General Comments

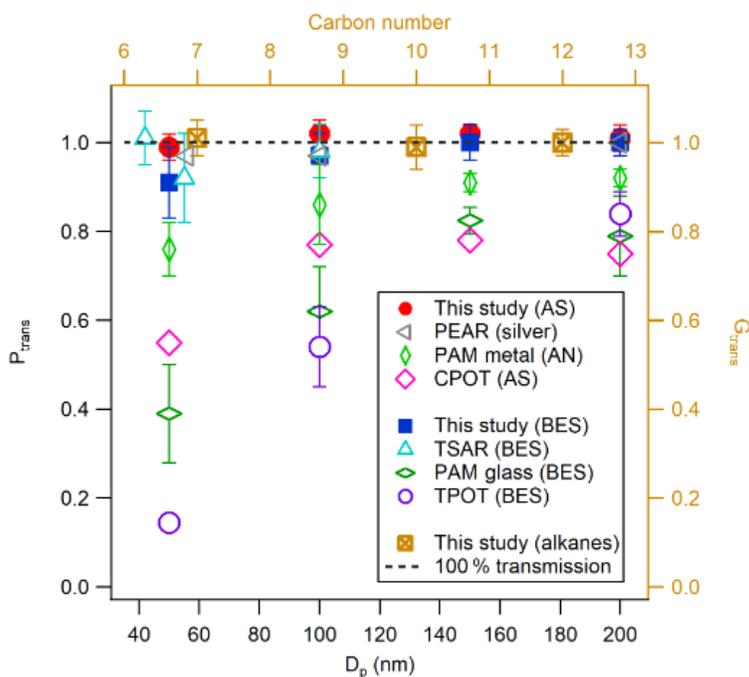
The comparison of particle penetration efficiencies is incomplete, and in some places is misleading. Figure 7 shows that the size-dependent particle penetration efficiencies of PFA, PAM and TPOT OFRs, and as presented, suggests that the PFA performance is the best of the three. However, as noted in L215-L220, the PFA was conditioned for 12 hours prior to testing to suppress static discharge, whereas the other OFRs were not. Thus, results are a combination of OFR design and testing procedure, and how to isolate the relative importance of each factor is not clear. Either results for the PFA prior to conditioning also need to be shown for a direct comparison, or this difference needs to be more clearly identified in the figure/caption. Figure 7 also does not show published particle transmission efficiency data for several other OFR designs that were already referenced in this paper. Please see Figure 2 from Li et al., 2019, reproduced below for reference; to my knowledge, this is the most comprehensive comparison to date:

Answer: We added the data for the CPOT, TSAR, and ECCC-OFR to the revised [Figure 6](#). The results are not meant to be misleading. Our intent is to always minimize charge prior to

measurements. Though we have not tested this extensively yet, it is our belief that the charge will not return until and unless the OFR is disassembled or relocated.
